Access Compliance Report

Public Rights-of-Way (Curb Ramps)

Intersection ID: 7036	Main Street: BEATTIES_FORD_RD	Cross Street: MCALLISTER_DR	Location: SE
ADA ID: FF609A6E3CBC	Ramp Type: PerpDiag	Initial Pass/Fail: Fail	Overall Compliance: No
Severity Score: 21.25			
Codes/Mitigation Info/Possible Solution		Field Measurements/Component Compliance

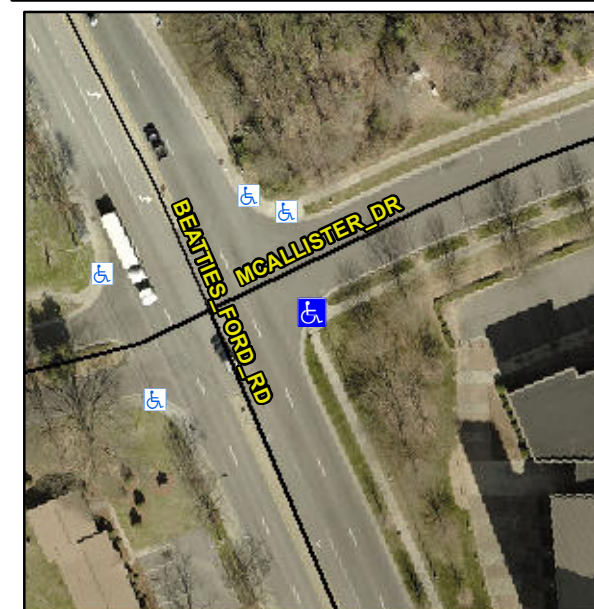
Not Found, R304.5.1, R304.2.2

Compliance	Description	Data	Compliance	Description	Data
N/A	Ramp Length (in)	35.0	No	Ramp Slope (%)	9.4
No	Ramp Width (in)	44.0	Yes	Ramp XSlope (%)	0.5
N/A	Flare Type LT	N/A	N/A	Flare Type RT	N/A
N/A	Flare Slope LT (%)	N/A	N/A	Flare Slope RT (%)	N/A
N/A	Flare Traversable LT?	N/A	N/A	Flare Traversable RT?	N/A
N/A	Landing Length (in)	N/A	N/A	DWS Provided?	N/A
N/A	Landing Width (in)	N/A	N/A	DWS Contrast?	N/A
N/A	Landing Slope (%)	N/A	N/A	DWS Length (in)	N/A
N/A	Landing X Slope (%)	N/A	N/A	DWS Full Width?	N/A
N/A	Landing Curb? (Y/N)	N/A	N/A	DWS Offset (in)	N/A
N/A	Shared Landing?	N/A			
N/A	Gutter Ponding?	N/A	N/A	Gutter Slope (%)	N/A
N/A	Gutter Lip Ht (in)	N/A	N/A	Gutter X Slope (%)	N/A
N/A	Painted X Walk1?	No	N/A	Painted X Walk2?	No
	X Walk 1 Direction	To N		X Walk 2 Direction	To W
N/A	X Walk 1 Width (in)	N/A	N/A	X Walk 2 Width (in)	N/A
	X Walk 1 Slope (%)	0.1		X Walk 2 Slope (%)	0.1
	X Walk 1 X Slope (%)	1.5		X Walk 2 X Slope (%)	1.7

Remove & Replace Curb Ramp With Two New Directional Ramps or Equivalent.
